From: Cushman, George H IV CIV USARMY HQDA DCS G-9 (USA) <george.h.cushman.civ@army.mil>
Sent: Friday, March 11, 2022 11:13 AM
To: Wear, Benjamin, NMENV <Benjamin.Wear@state.nm.us>
Cc: Thomas, Ian M CIV USARMY HQDA DCS G-9 (USA) <ian.m.thomas2.civ@army.mil>; Soicher, Alan J CIV USARMY CESPA (USA) <Alan.J.Soicher@usace.army.mil>; Christy Esler <cesler@sundance-inc.net>; Angela Makin <amakin@sundance-inc.net>
Subject: FWDA Parcel 3 Well Installation Project

Figure 3-2

Proposed Replacement Well Locations

Parcel 3 Groundwater Background Wells and Replacement Monitoring Wells Installation Work Plan,

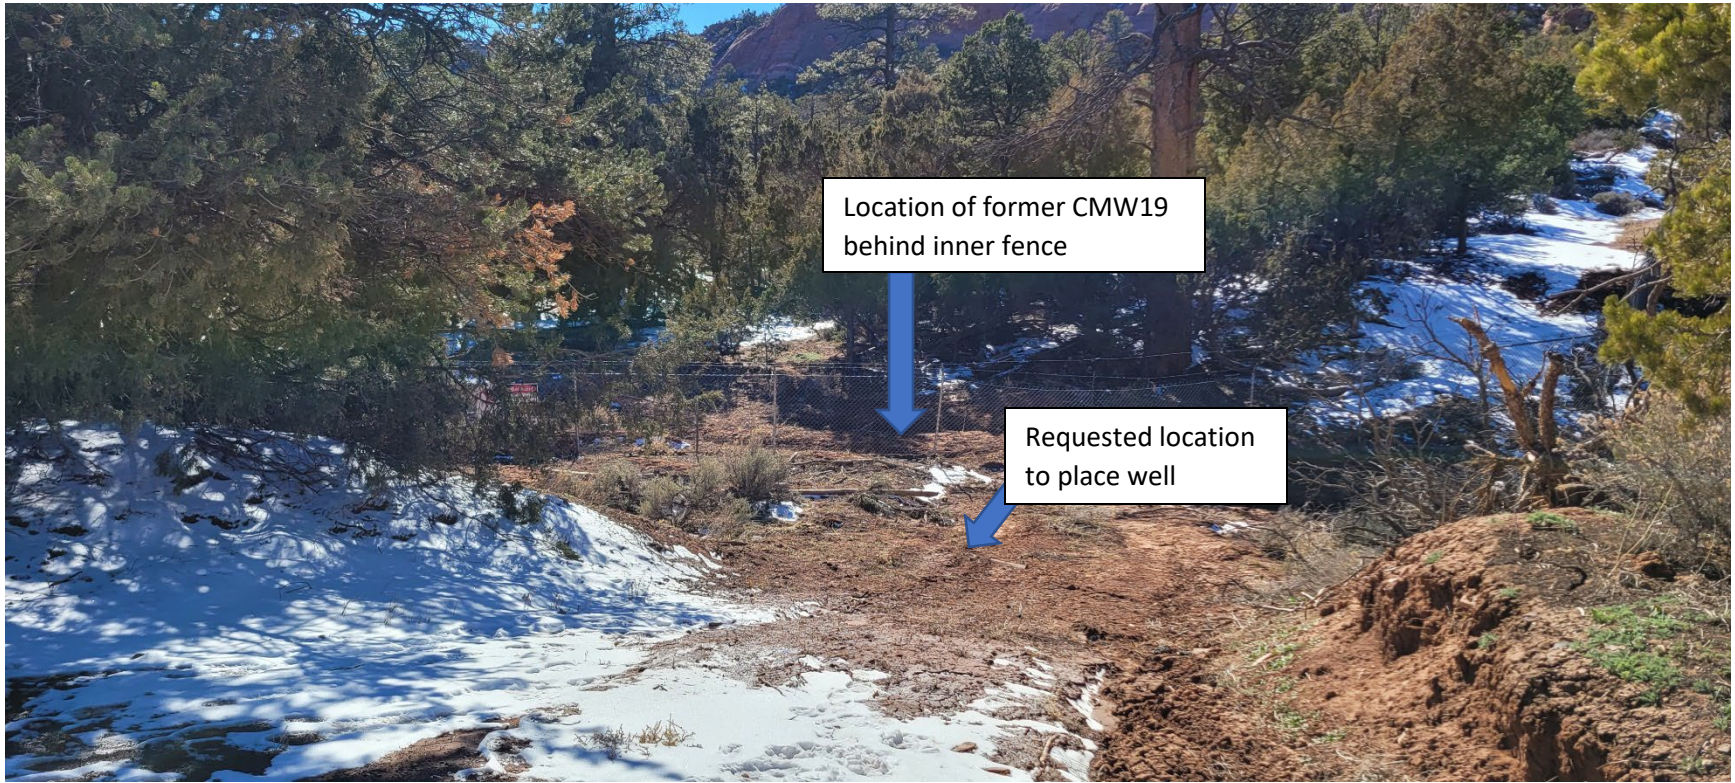
Ben: I'm writing to request your approval for a proposed change in location for one of the replacement monitoring wells in the FWDA Parcel 3 Well Installation project. As shown in the attached figure, the original location of the well was just inside the inner fence boundary. The proposal is to place the well immediately outside the inner fence, approximately 50-80 feet away from the original well's location.

The purpose of this change is to simplify access, improve safety, and avoid impacting the fence. The new location is adjacent to the arroyo that the previous well was targeting, and the elevation is consistent with the previous location. Attached is a photograph showing the previous location and the proposed location, and also a map view of the overall distance.

Location of former CMW19
behind inner fence

Requested location
to place well

The change in location for well CMW43 is approved.
